ATTACHMENT D

STOP INFRASTRUCTURE (KIT) AND CANOPIES

City centre
Canopies

- QVB eastern canopy – 24m long, 3.85m kit

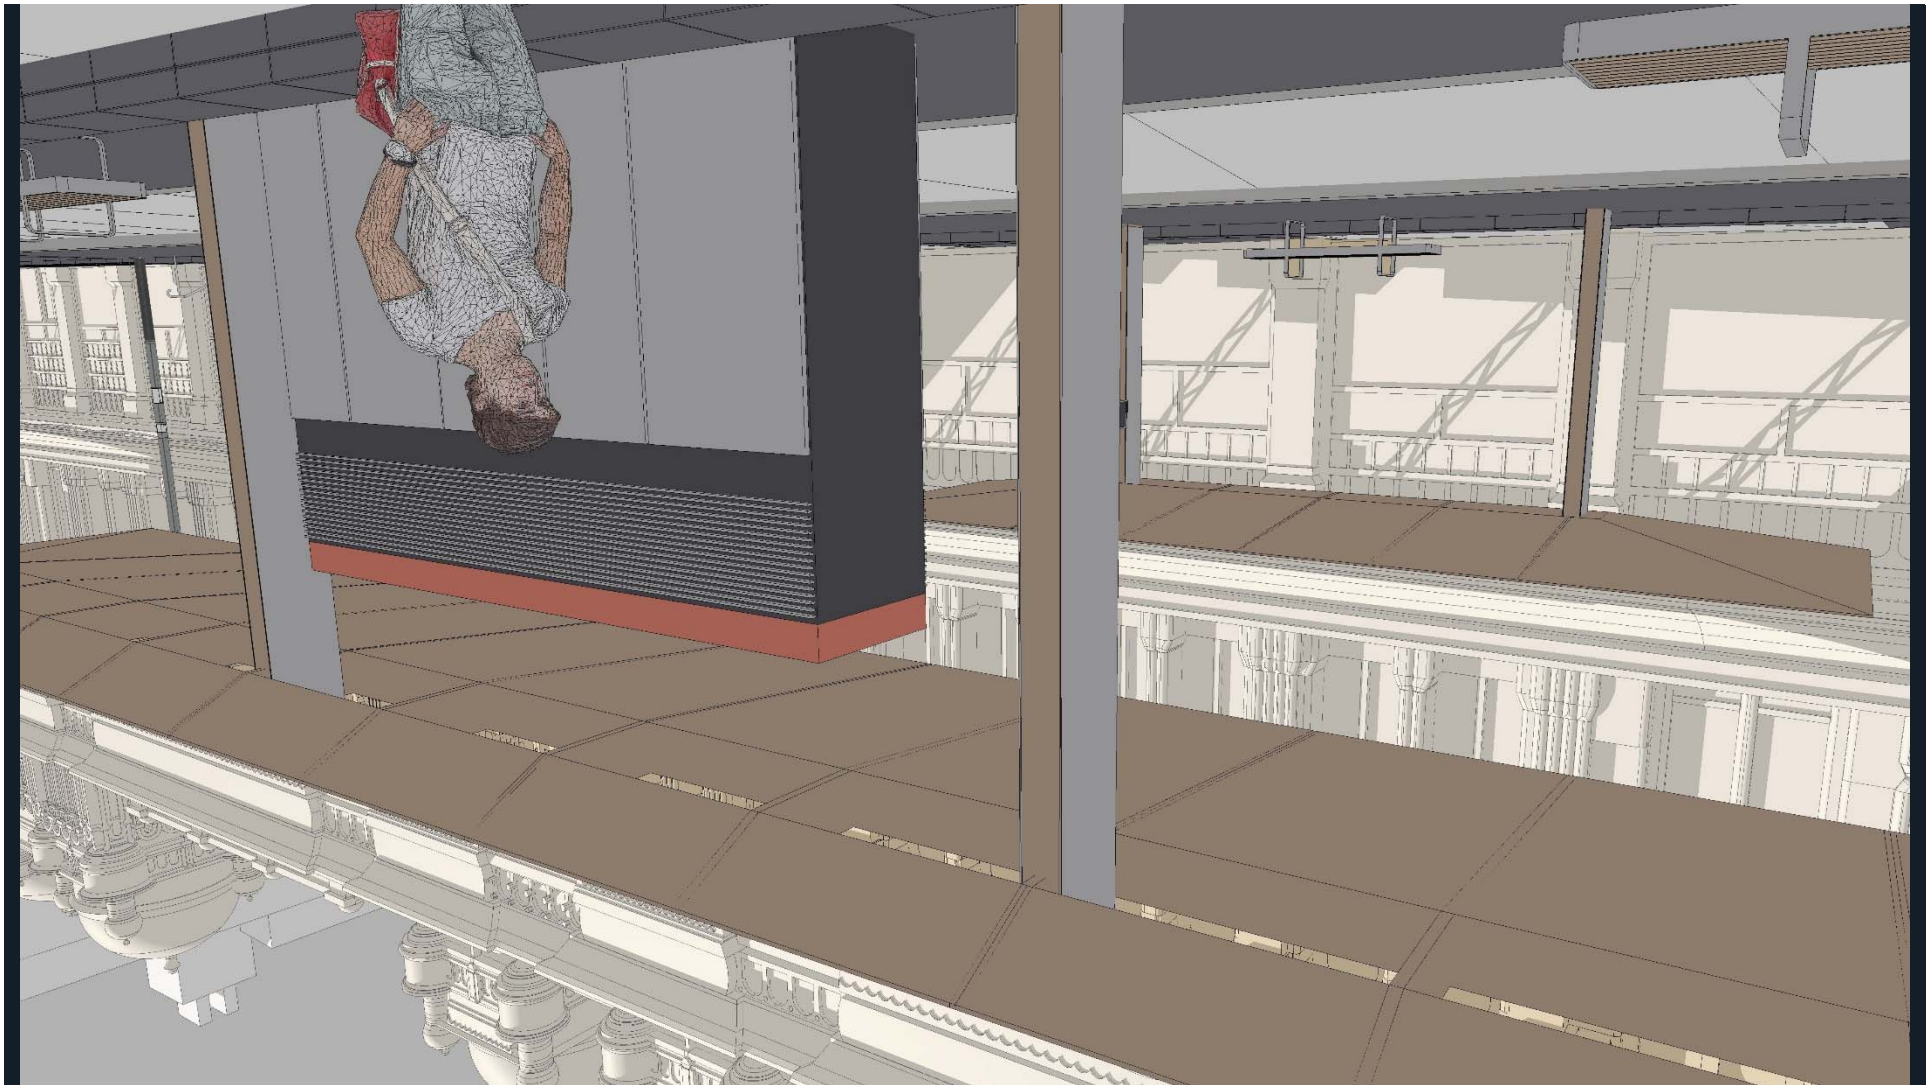
- We continue to advocate for smaller canopies at Wynyard and QVB

- Reduce the Wynyard and QVB eastern canopies to minimum size - 9.6m

- Wynyard eastern canopy – 24m long, 3.85m kit

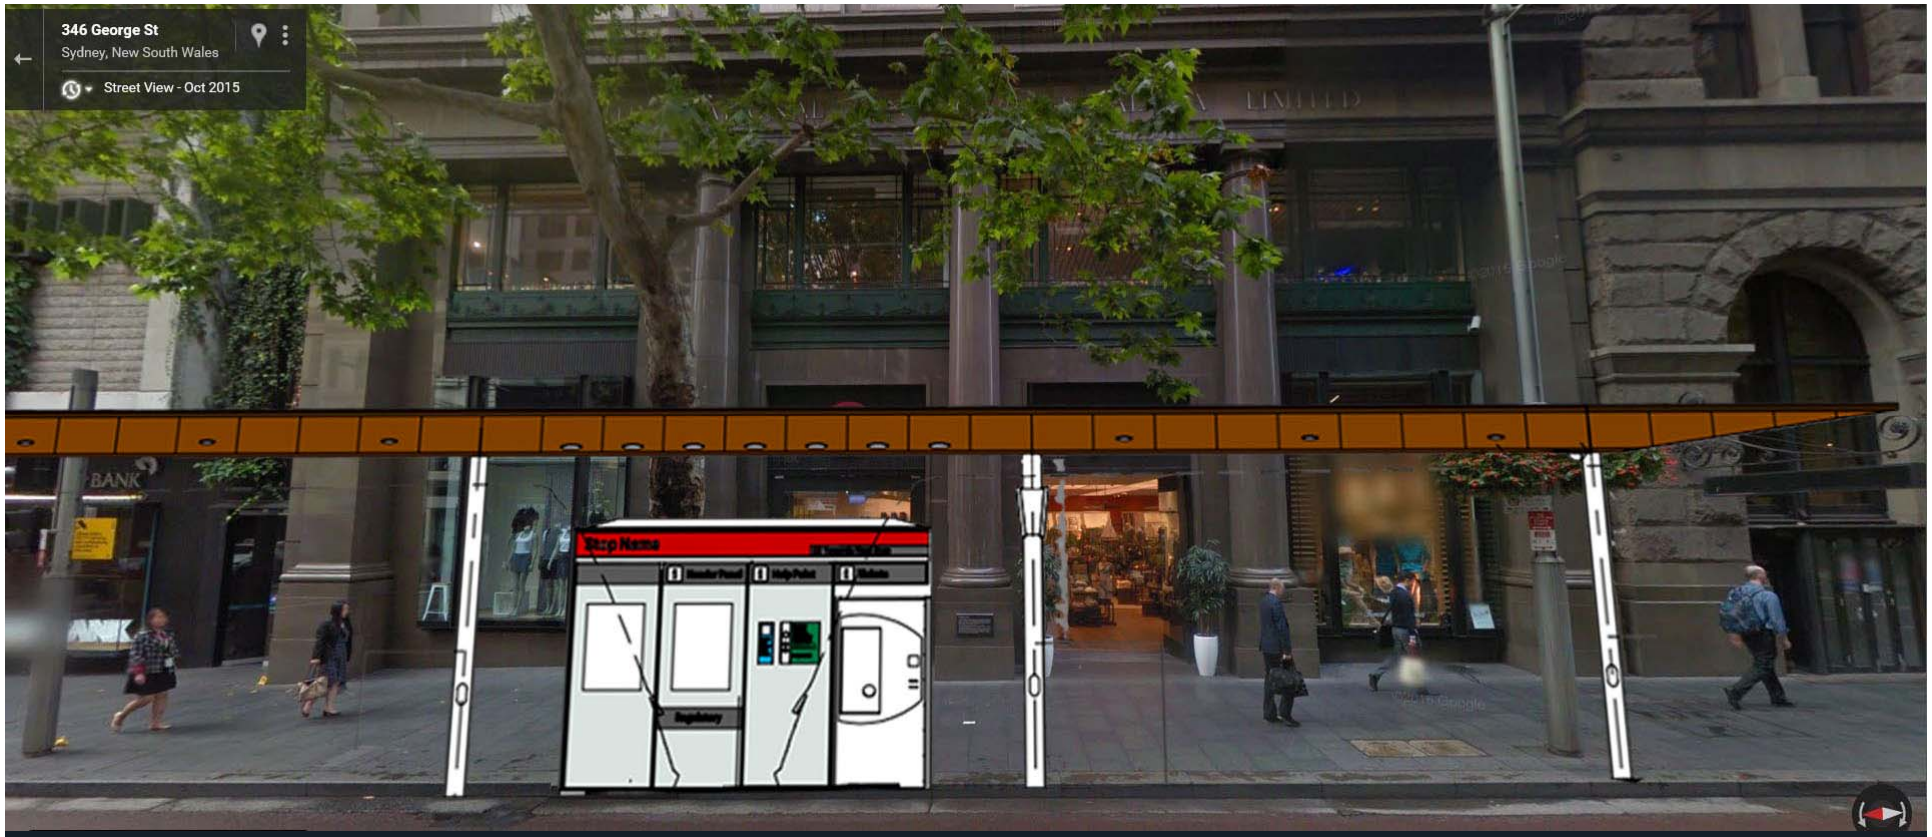
- Kit at QVB and Wynard is not minimal .
- City request the kit at QVB and Wynard eastern platforms be removed or at minimum reduced.
- City offered space in the QVB.
- TfNSW have advised that no kit will be moved, despite the signal and UPS cabinets being relocated off the platform at Town Hall.
